2. AMENDMENT/MODIFICATION NO. A001	3. EFFECTIVE DATE 12/23/2013	4. REQUISITION/PURCHASE REQ. NO. PR2967106-A001	5. PROJECT NO. (If applicable)
---------------------------------------	---------------------------------	--	--------------------------------

14. DESCRIPTION OF AMENDMENT/MODIFICATION (Organized by UCF section headings, including solicitation/contract subject matter where feasible.)
The purpose of this amendment is to post the questions and answers, reflect some changes as detailed on the following pages and extend the submission of offers time and date 10:00 from December 30, 2013 to 10:00 am January 10, 2014.

QUESTIONS AND ANSWERS

**ELECTRICAL INSTALLATIONS
REQUIRED FOR GUARD BOOTHS IN CALZADA SAN CARLOS**

**LAYOUT FOR ELECTRICAL RUNS TO
THE GUARD BOOTHS IN CALZADA
SAN CARLOS**

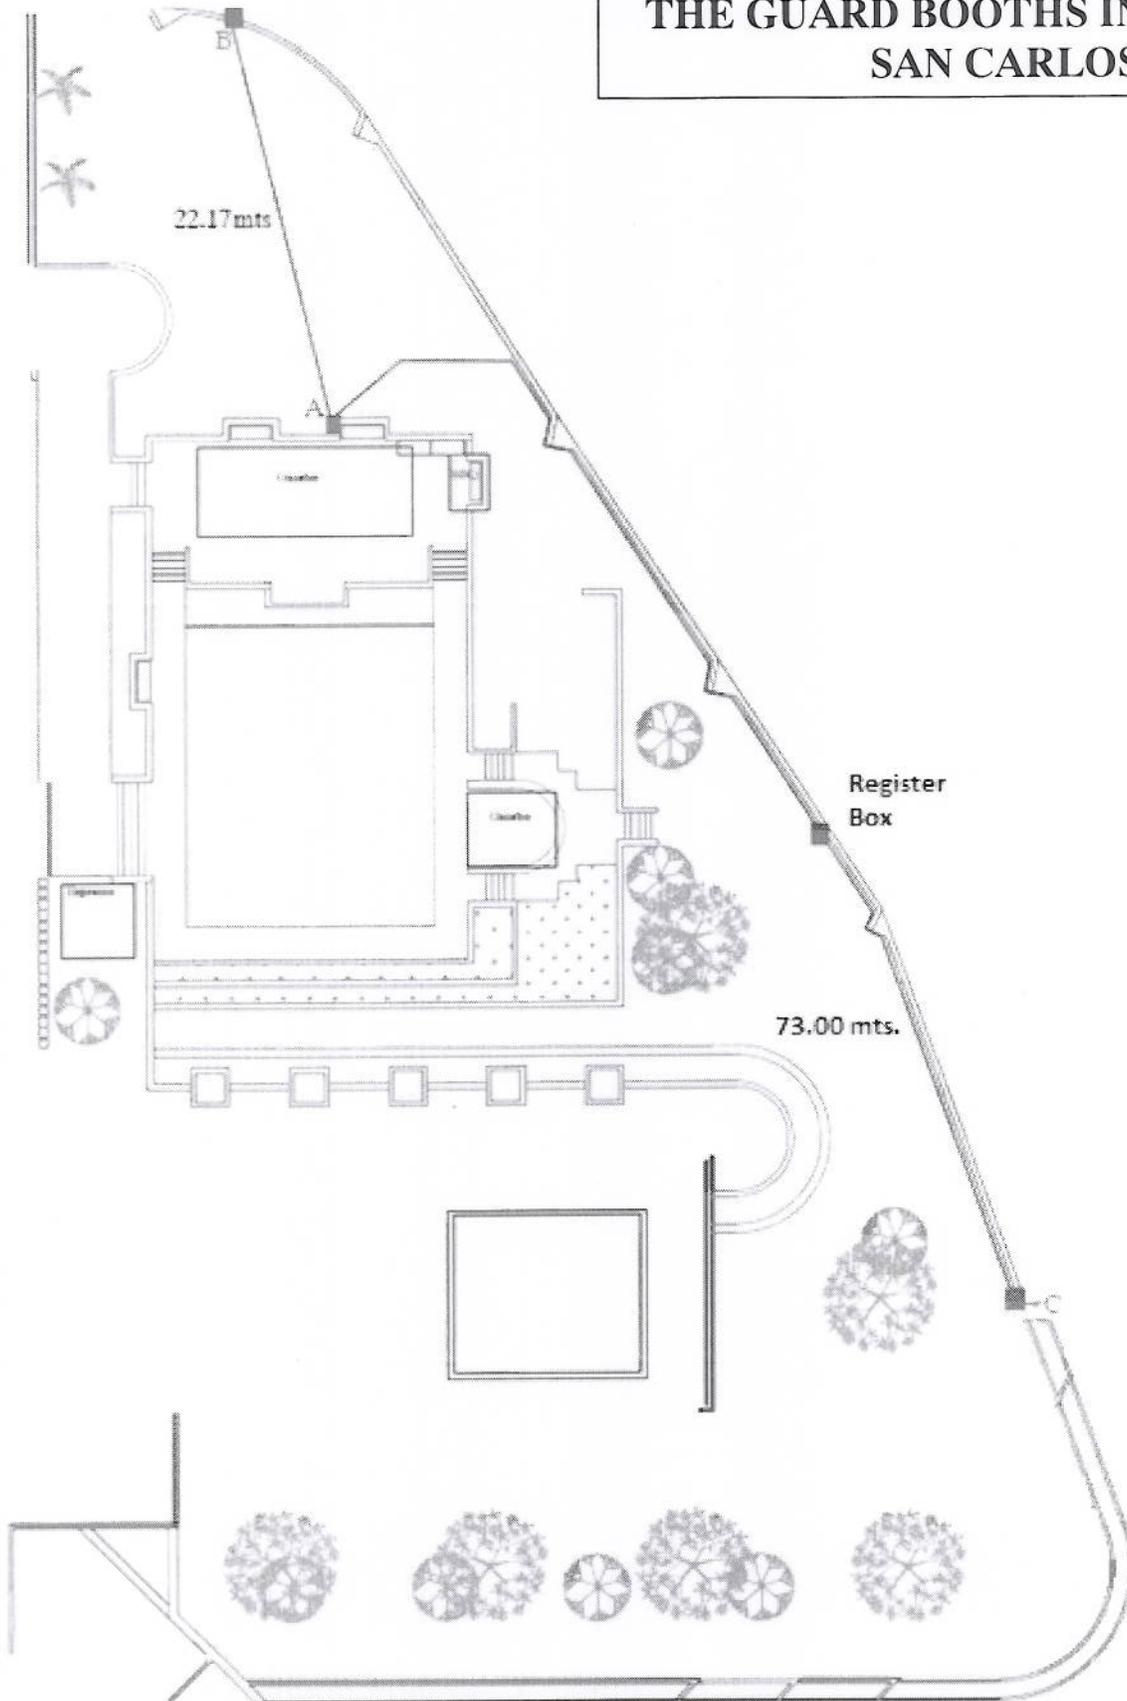
5. How will electricity be provided to the guard booths? Please specify routes for electrical feed for each booth. .
 - *Below please find scope of work for the electrical portion of this project. The contractor will be required to provide all materials and labor required to complete the scope of work. Any activity carried out inside the embassy compound will require escort at all times and the contractor will be required to coordinate this activities with the COR with 48 hours notice.*

7. What would be the location of the guard booths in the side walk?
 - *The Guard booth on the corner of Calzada San Carlos and Calle Republica de Mexico will be located on the Embassy side of the street in the inside of Calzada San Carlos after the electric utility pole located in the corner as shown in the layout below. The Guard booth on the corner of Calzada San Carlos and Avenida La Paz will be located on the Embassy corner directly where the garden structure ends..*

- a) Installation of 1 light fixture inside each guard booth (capacity of 1 standard light bulb) and 1 light fixture on the exterior of each guard booth (water proof exterior fixture with cover and a capacity for 2 standard light bulbs), both controlled by a double light switch installed inside of the guard booth. Similar to photo E-1 and E-2.
- b) Installation of 1 double grounded 20 amp outlet on the inside of each guard booth. (Outlet box should be installed inside the wall and not superficial)
- c) Installation of power feed to each guard booth. The contractor will install all necessary components and electrical wiring required to feed power to each guard booth from a point specified within the Embassy gardens.

- a) All electrical installation should follow American Standards.
- b) An exterior electrical panel will be installed by the contractor with a minimum capacity of 4 circuits (location A). The contractor will provide 1 breakers 20Amp, 1-phase for circuit running to point B and 1 breakers 30Amp, 1-phase for circuit running to point C.

- c) All wiring used in underground section A-B should be gauge No. 12 AWG THHN and should be installed in 1 inch electric PVC pipe CED-40. Circuit will consist of 3 wire (load, neutral and ground) and should follow color code. (Estimated: 22.17 mts.)

- d) All wiring used in underground section A-C should be gauge No. 10 AWG THHN and should be installed in 1 inch electric PVC pipe CED-40. Circuit will consist of 3 wire (load, neutral and ground) and should follow color code. A inspection box (4" x 4") should be install in the middle of the path of the underground pipe along the internal side of the Embassy perimeter wall. (Estimated: 89.68 mts.)

- e) From point B and C to each corresponding guard booth the circuit will be run through the wall and then run vertically down inside the wall and follow inside the side walk to the guard booth. At no point in the electric run will the pipe be exposed.
